NUMBER: 23-031-06

THIS BULLETIN SUPERSEDES TECHNICAL SERVICE BULLETIN 23-023-04, DATED JUNE 15, 2004, WHICH SHOULD BE REMOVED FROM YOUR FILES . ALL REVISIONS ARE HIGHLIGHTED WITH **ASTERISKS**** AND INCLUDE ADDITIONAL YEAR AND MODELS.**

Windshield Header Buzz Or Humming Sound

Fig. 1 JOINT TO BE SEALED

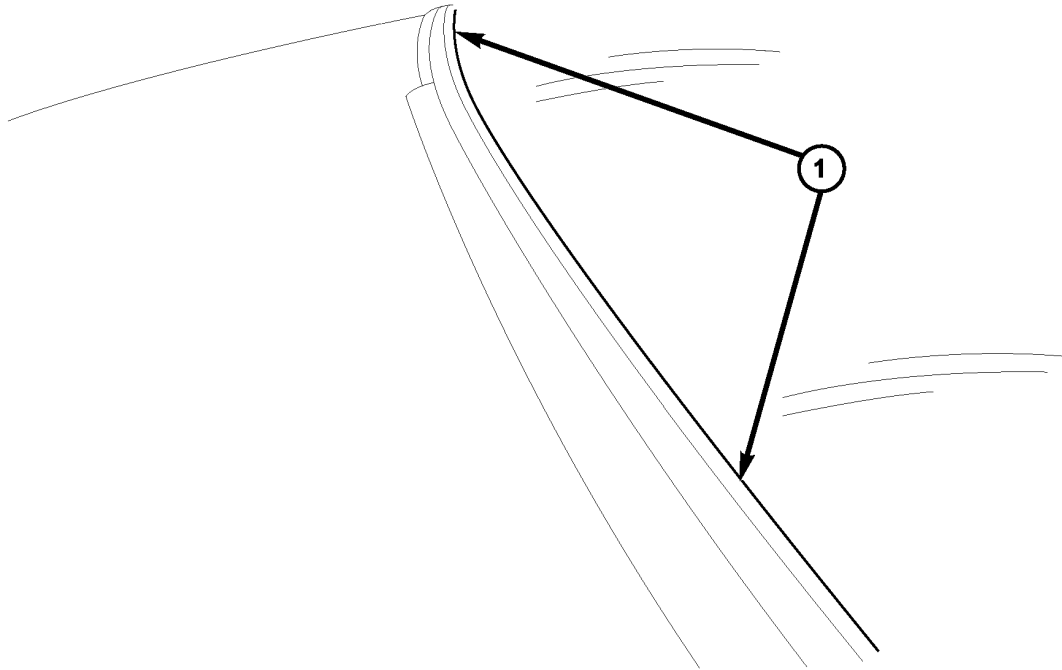
In warmer weather the vehicle operator may report a buzz or humming sound from the upper front windshield area particularly at speeds above 45 mph (72 kph). Some vehicles may have been built with the upper windshield molding partially rocked forward. When air passes over top of the tail section of the molding it may vibrate creating a buzz or humming sound and is more likely to occur in warmer ambient temperatures when the molding material is more flexible.

1. Use a trim stick to hold the tail section of the windshield molding away from the roof panel and use an alcohol wipe to clean all the way across the vehicle between the molding and roof panel.(Fig. 1).

1 - APPLY SEALER BETWEEN TAIL OF MOLDING AND ROOF PANEL

-
2. Use a trim stick to hold the tail section of the windshield molding away from the roof panel and apply MOPAR Silicone Windshield and Glass Sealer, p/n 04467708, in the joint between molding and the roof panel.
 3. If sealer squeeze out occurs, immediately wipe off the excess with a clean paper towel.
